**COMPARISON OF TWO GROUND-WATER FLOW MODELS FOR  
ADMINISTRATION OF WATER RIGHTS IN THE  
SOUTHERN JORNADA DEL MUERTO BASIN  
LOWER RIO GRANDE UNDERGROUND WATER BASIN  
DOÑA ANA COUNTY, NEW MEXICO**

**New Mexico Office of the State Engineer  
Hydrology Report 01-6**

**July 2001**

Figure 2. Finite-difference grid for the OSE model of the Southern Jornada Basin

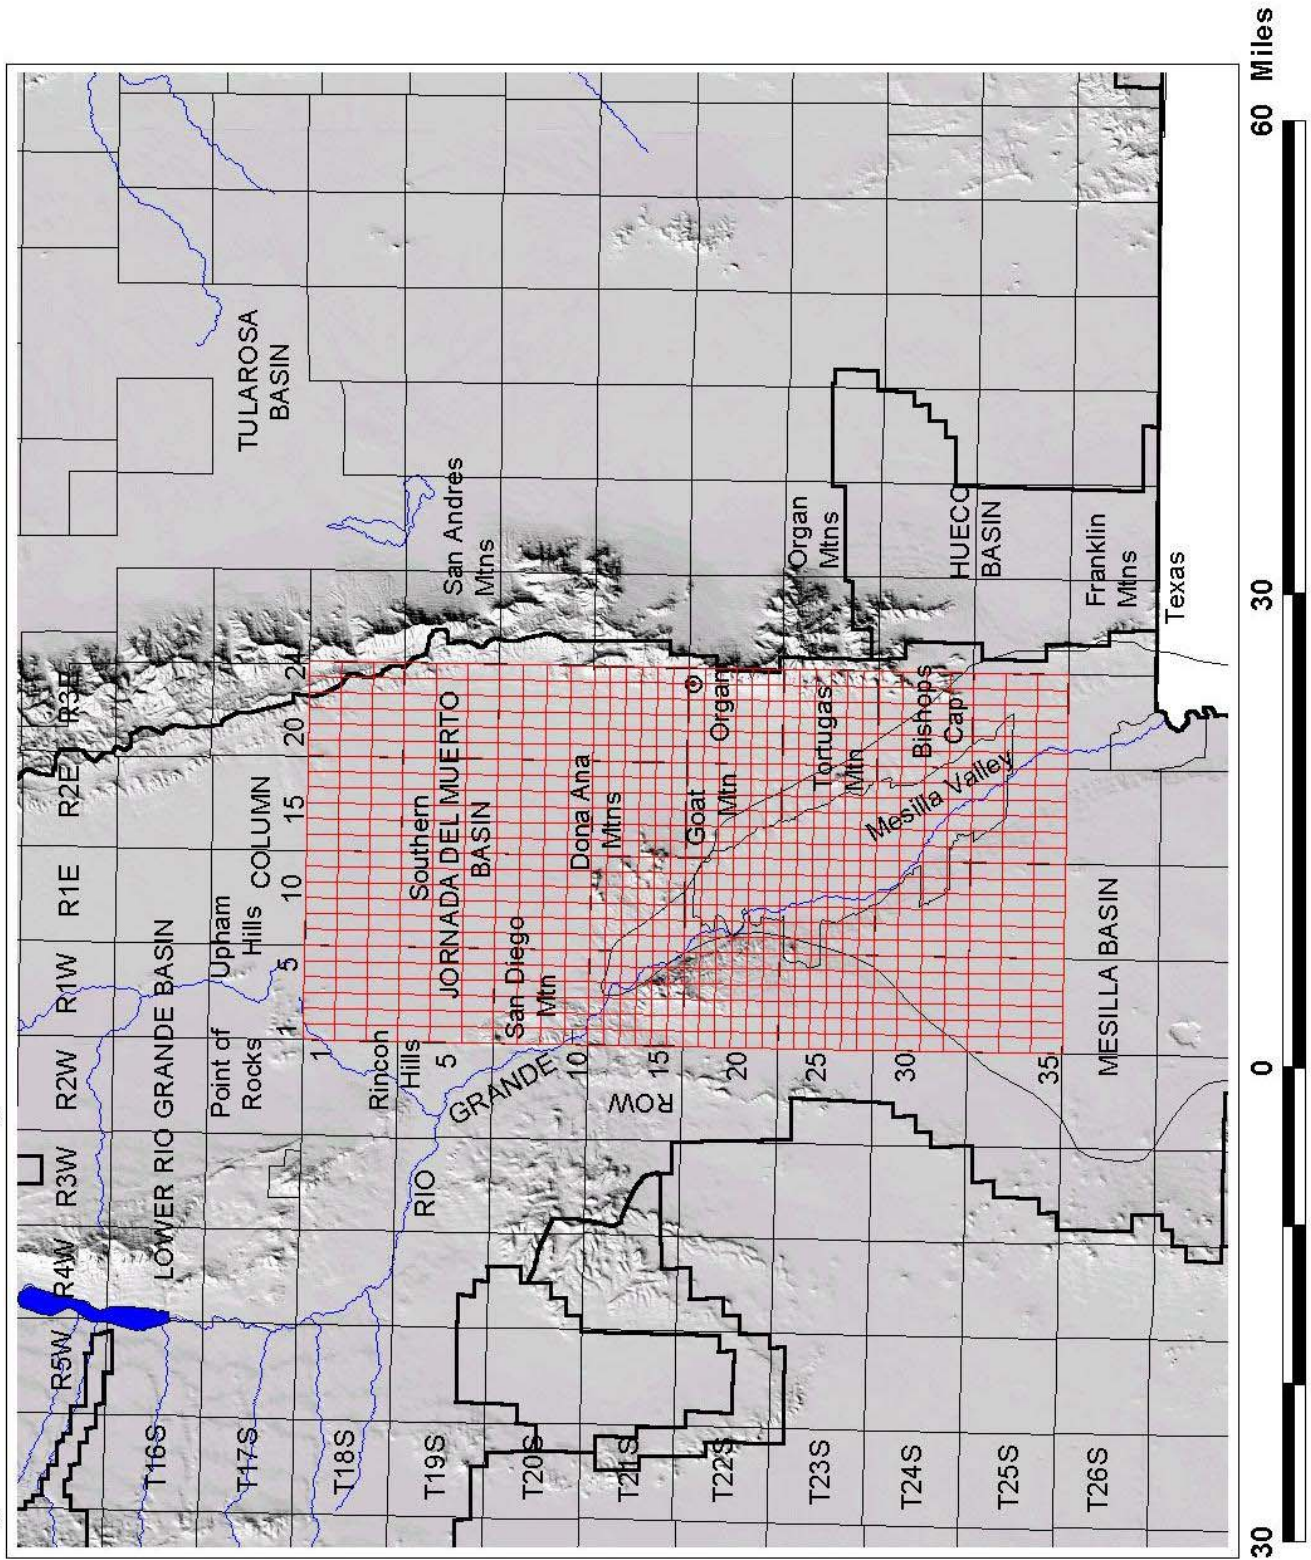
The OSE model is a superposition model, simplifying its use for water rights administration. Also, the OSE model grid is oriented with columns running north-south and rows running east-west (table 1, figure 2). Model cells are thus aligned with and in some cases correspond with sections in the public land survey system (figure 2). This facilitates locating existing wells and proposed well locations on the grid.

Figure 3. Finite difference grid for the JSAI model of the Southern Jornada Basin

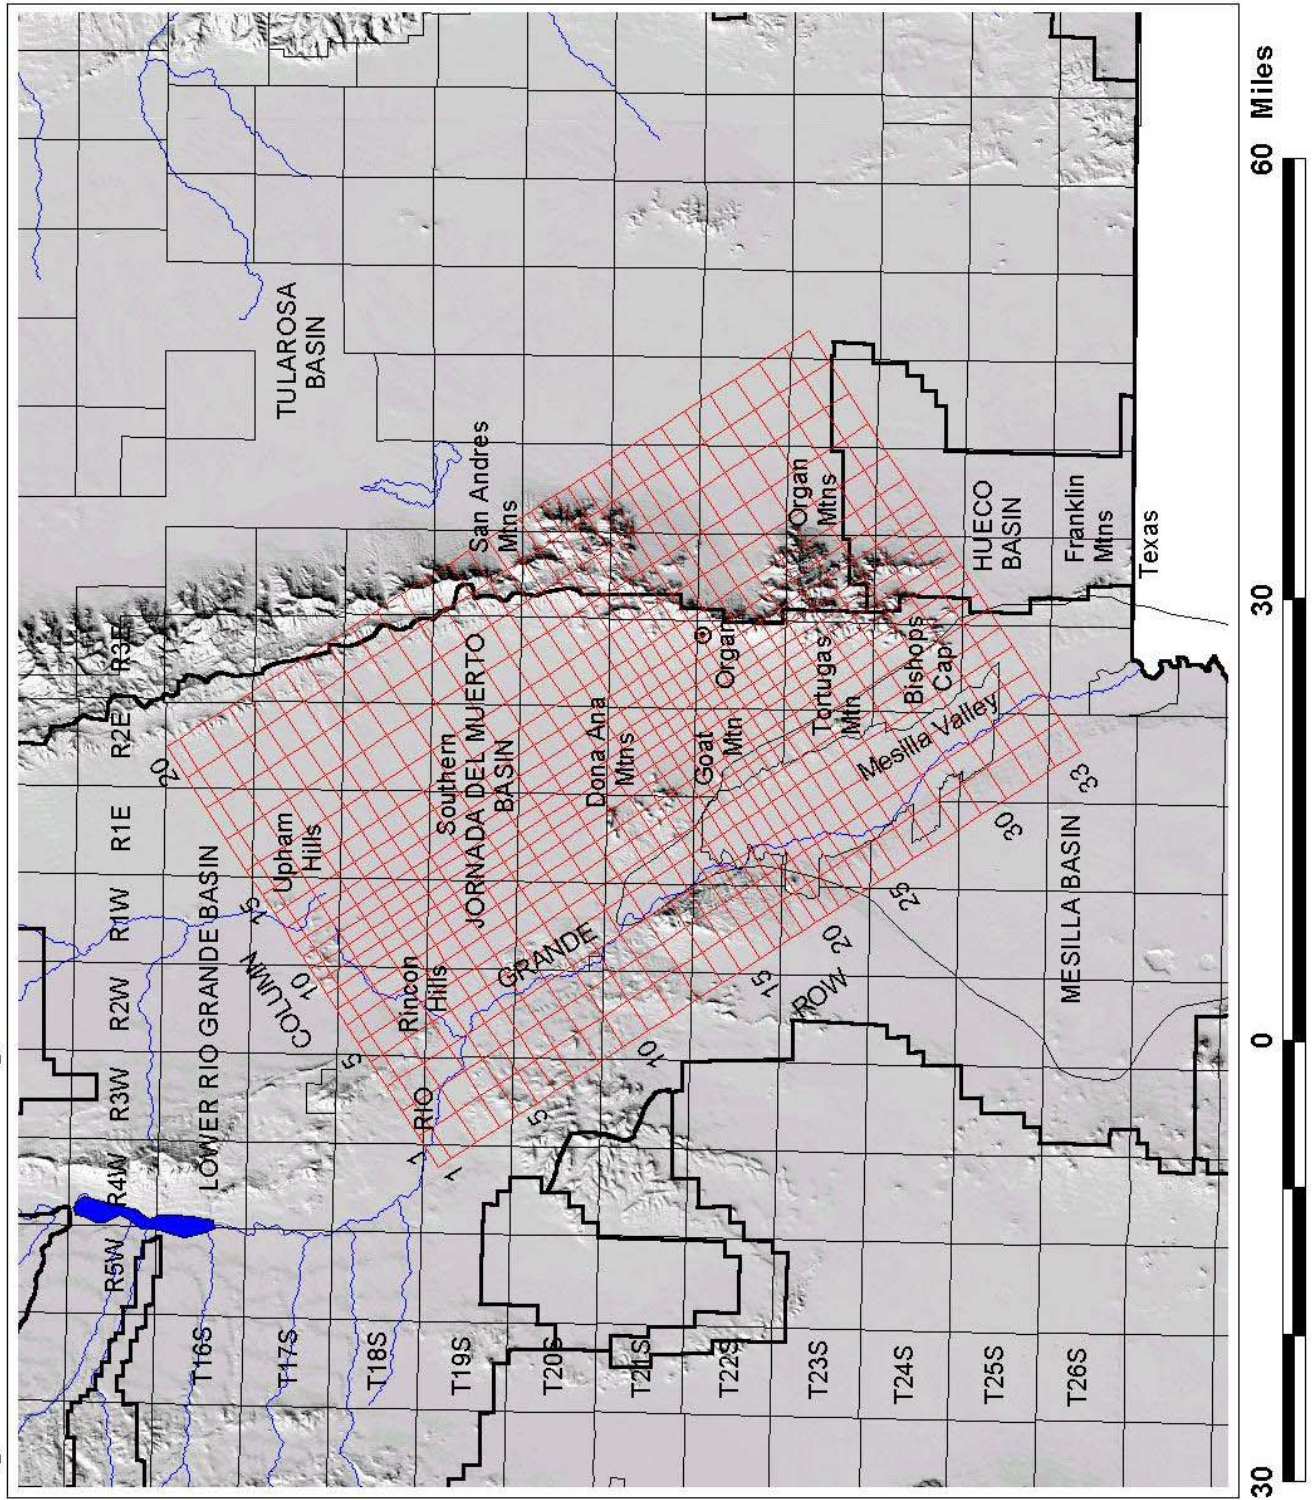
Whenever possible the axes of finite-difference grids should be aligned with the principal directions of the hydraulic conductivity tensor (Anderson and Woessner, 1992). Water-table contour maps (Wilson and others, 1981; plate 9), and basin stratigraphy and structure (Hawley, 1984; Seager and others, 1987), indicate that the JSAI model grid is aligned more closely to the presumed principle directions of hydraulic conductivity.
